Strathfield Internal Development Assessment Panel Meeting

Friday, 23 August 2019

SUBJECT: DA2019/059 - 2 MALVERN CRESCENT, STRATHFIELD
LOT A DP 383046

DA NO. DA2019/059

Figure 11: Extract from garage level plan (L) and ground level plan(R), with areas of non-compliance shown highlighted.

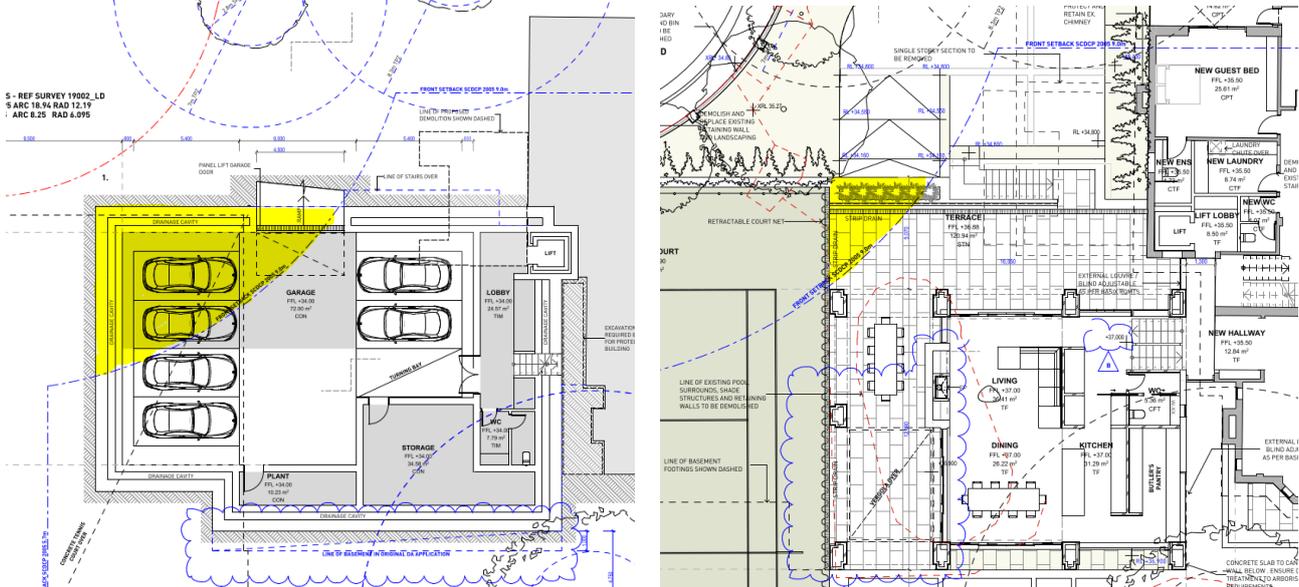
Comments: The street setback of the proposed addition accommodating the garage does not achieve the minimum 9m setback to the street frontage as required by Table A1, shown below. The upper level accommodating the living/dining/kitchen arrangements achieve the setback requirements with the exception of the northwest corner of the associated terrace, also shown.

This site is unusual in its shape due to the subdivision of the grounds of ‘Radstoke’ to create Malvern Crescent and the cul-de-sac end, resulting in a shallow allotment with an irregular street boundary and corresponding irregular setback line.

Figure 6: Extract of the site plan showing approximate location of Right of Drainage easement and proximity to the proposed garage.

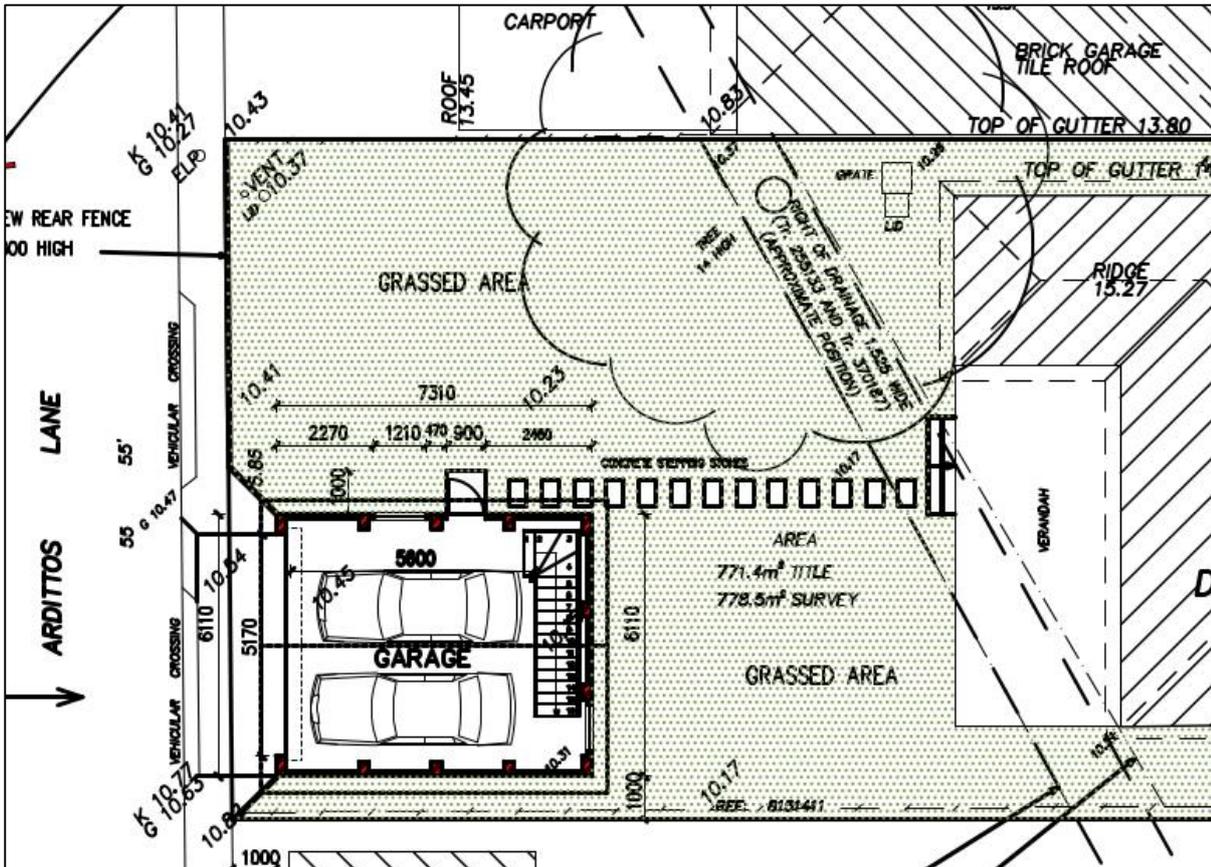
The property is burdened by a Council drainage pipe which intersects the lot within the north-western portion. A 1.525m wide right of drainage is located over the pipe. The development is considered to be adequately setback from this pipe as shown below in Figure 6.

Figure 7: Proposed northern (Ardittos Laneway) elevation.

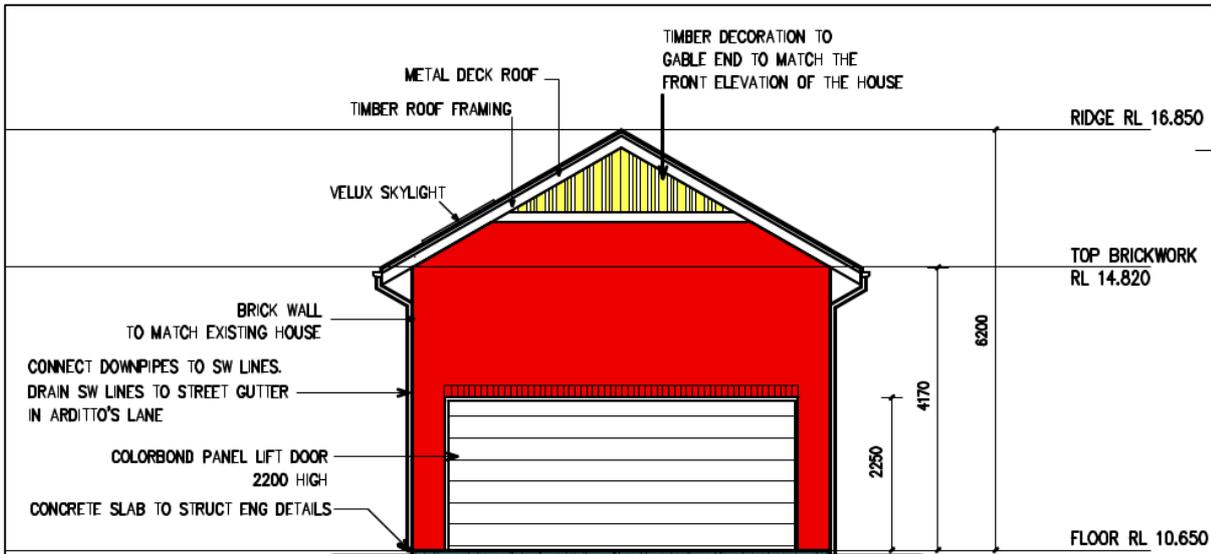
Details regarding the proposed rear fence are lacking on the elevation plans, however the annotations on the site plan state that a 1.8m in height rear fence is proposed along Arditto Lane. The proposal was not notified with the boundary fencing in the description but it is considered acceptable as there is existing 1.8m rear boundary fencing. This is not the main part of the proposal, the boundary is not shared with another property and the site plan clearly shows this in its annotations.

Figure 9: Proposed eastern elevation of the garage.

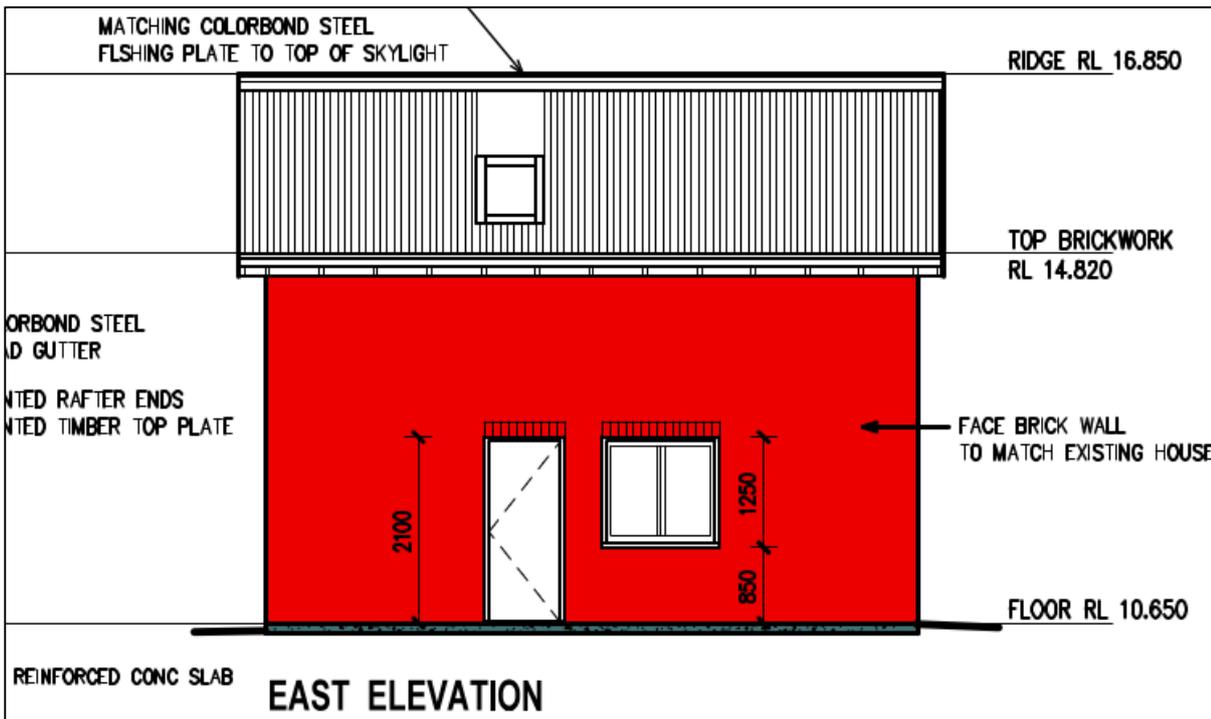
Comments: The proposal incorporates a minimum number of windows and doors and these are positioned on elevations so that they are not highly visible from the public domain. Smaller sized windows have been included on the first floor level and their size has reduced the overall visible glazing on the garage. One (1) skylight is proposed on the eastern side of the pitched roof form, which is not visible from Ardittos Lane (Figure 9).
